PUBLIC INTEREST REVIEW FOR GROUNDWATER APPLICATIONS

TO: Water Rights Section Date 4/29/2015
 FROM: Groundwater Section Michael J. Thoma
Reviewer's Name
 SUBJECT: Application G- 18050 Supersedes review of _____
Date of Review(s)

A. GENERAL INFORMATION: Applicant's Name: Jason Cole, Elizabeth Cleary-Cole
 County: Josephine

Figure 1A: Water Availability Table – Powell Cr.

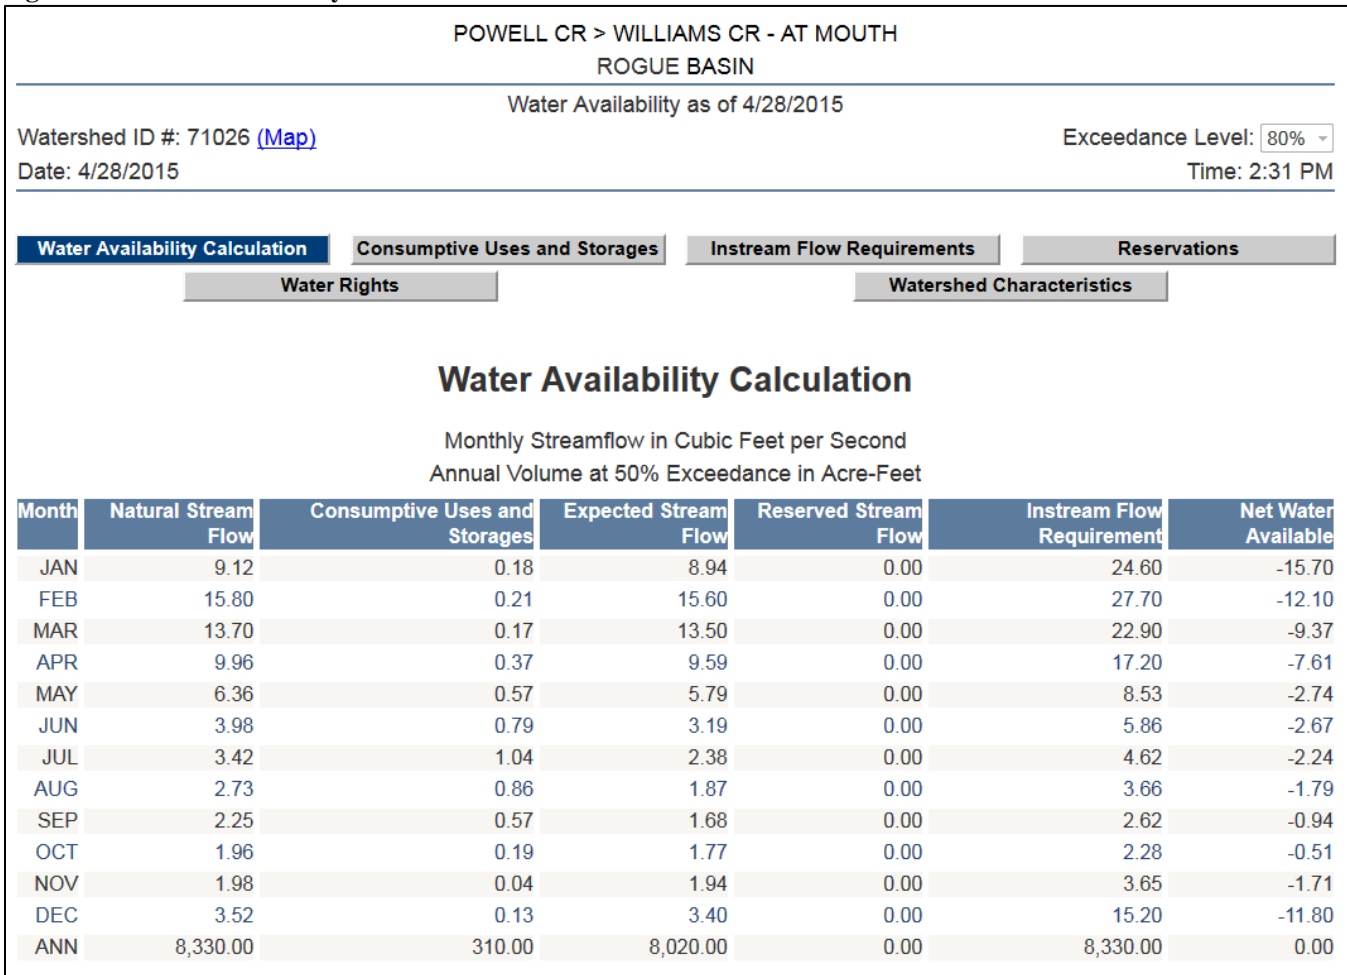
Comments: The proposed use of 0.13 cfs is > 1% of the minimum monthly 80% natural flow in Powell Cr. (Figure 1A) and > 1% of instream right IS71026A (Figure 1B). Therefore PSI is assumed.

Figure 2: Application Overview Map

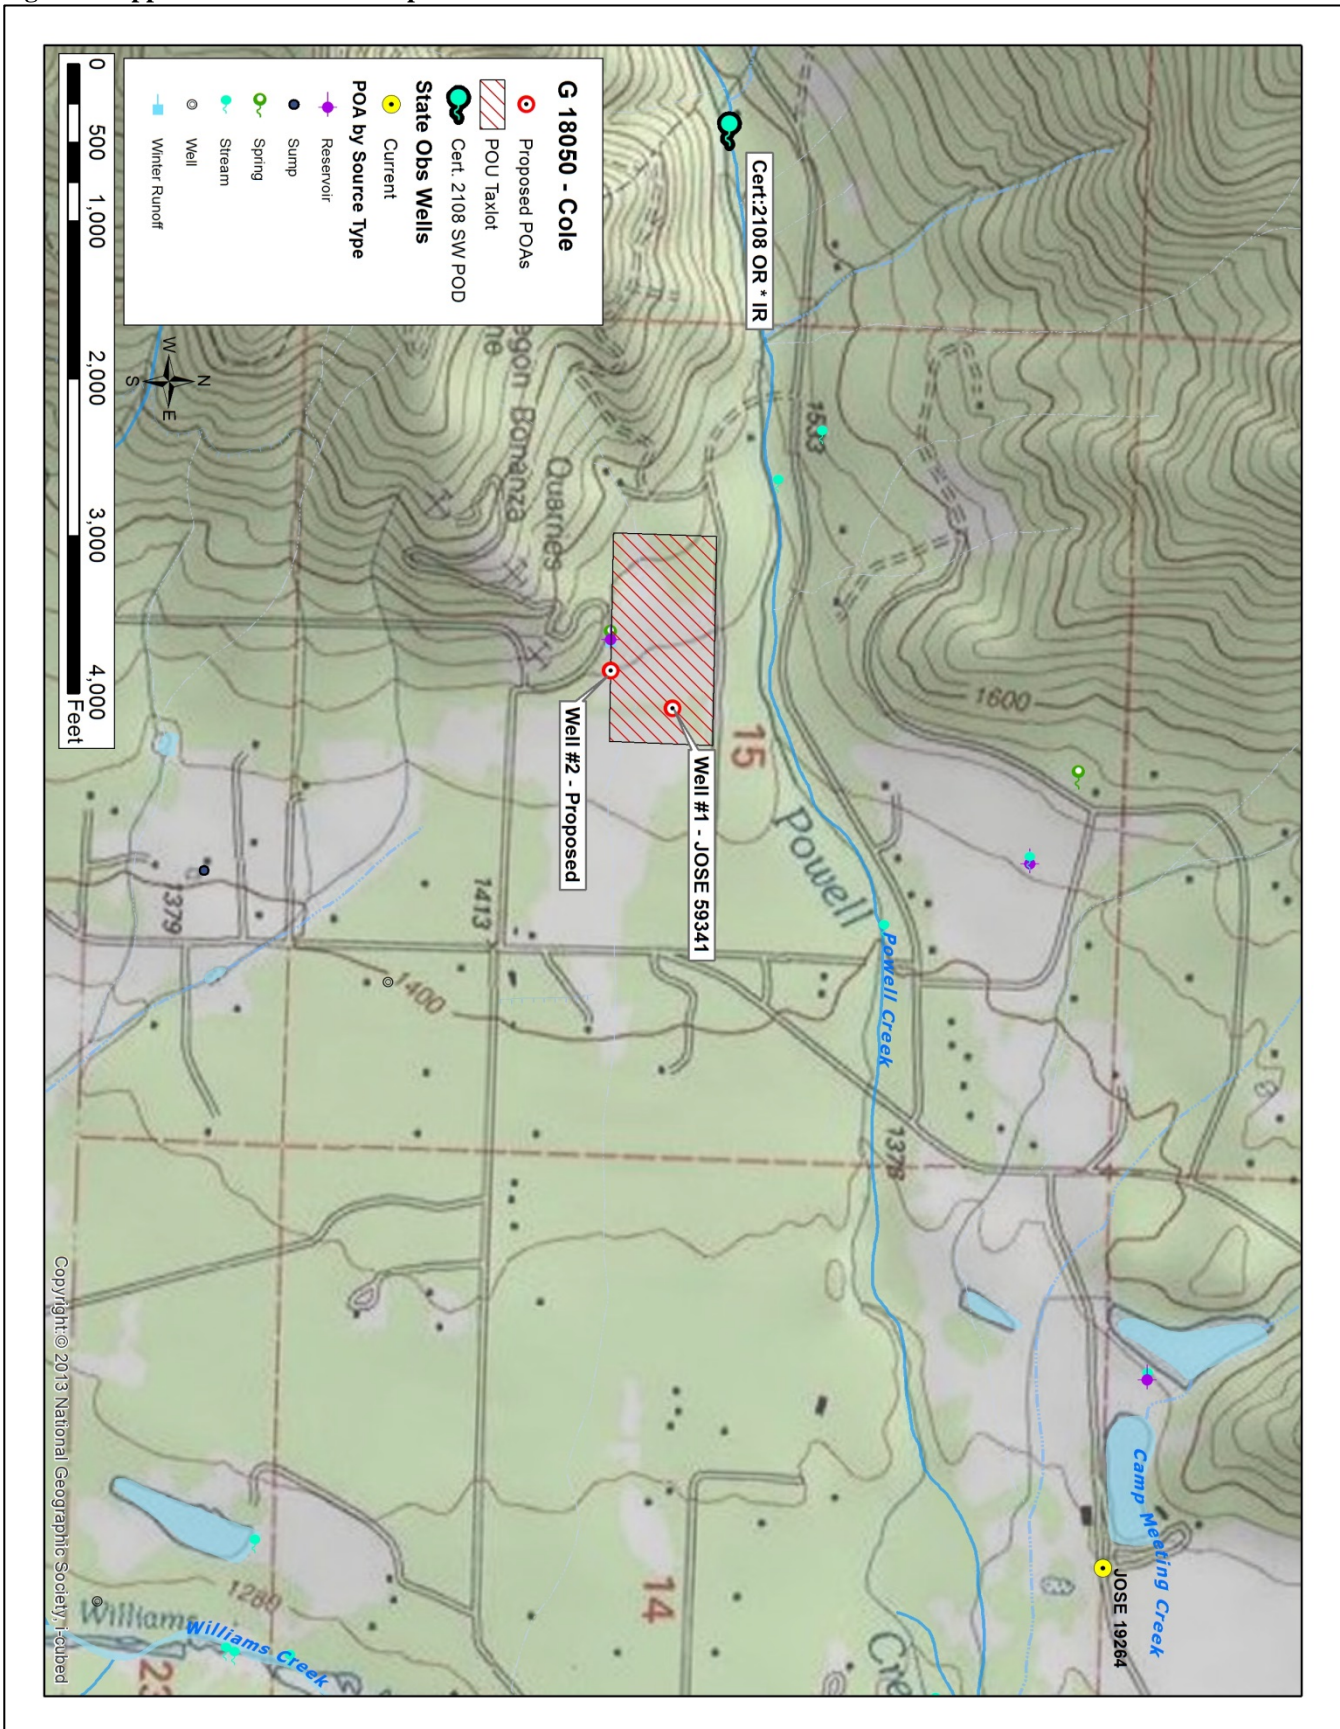
B3. **Groundwater availability remarks:** The applicants' proposed POAs sit at the flanks of the Williams Creek Valley and will be producing from fractured bedrock of the Applegate Grp. (Ramp and Peterson 1979) (Figure 2). Yields reported on driller's logs for nearby wells generally range from < 1 gpm (<0.01 cfs) to near 100 gpm (0.22 cfs) but the applicants' existing well reports 13 gpm (0.02 cfs) which is probably closer to the average yields for the fractured aquifer system. Regardless, it is possible that the applicants' proposed rate of 0.13 cfs can be obtained from a combination of two wells and their use is within the capacity of the resource.
